**TRANSMISSION—E4OD—HEAT STAINED OVERDRIVE PLANETARY GEARSET, COAST CLUTCH CYLINDER BUSHING AND/OR OVERDRIVE CYLINDER BUSHING**

**Article No.  
95-21-9**

**FORD:** 1995 BRONCO, ECONOLINE, F SUPER DUTY, F-150-350 SERIES

Figure 1 - Article 95-21-9

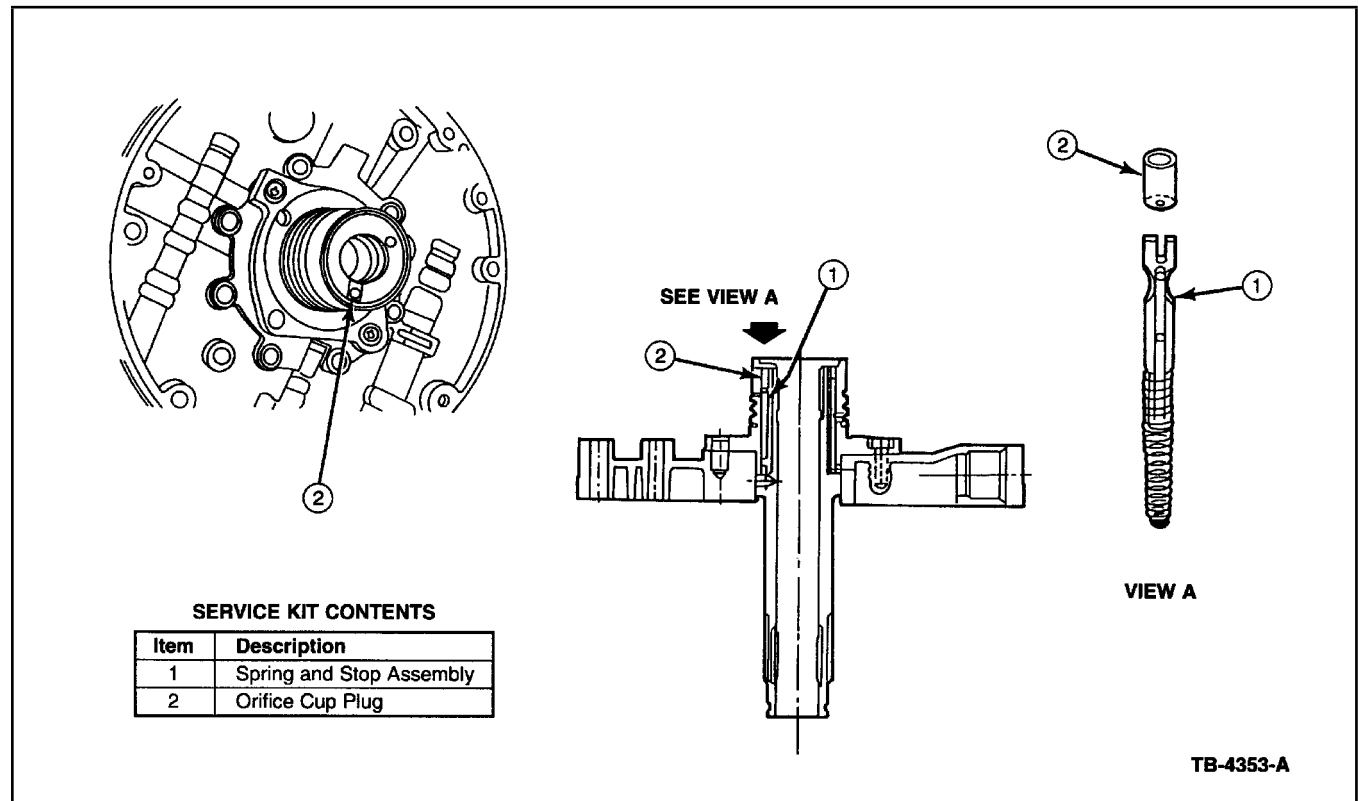
Some E4OD transmissions with build dates between 5B03 (February 3, 1995) and 5E31 (May 31, 1995) may have a valve, in the pump, that restricts fluid flow (Figure 1). This valve may become stuck in the valve bore and restrict lubrication. Symptoms may include heat distress on the overdrive planetary gearset, coast clutch cylinder bushing and/or overdrive cylinder bushing.

During overhaul of E4OD transmissions with build dates 5B03 and 5E31, inspect the components listed above for signs of heat distress. Replace the valve assembly using a service valve kit

(E9TZ-7H132-B) which should resolve the issue. Refer to the Instruction Sheet included in the kit for details.
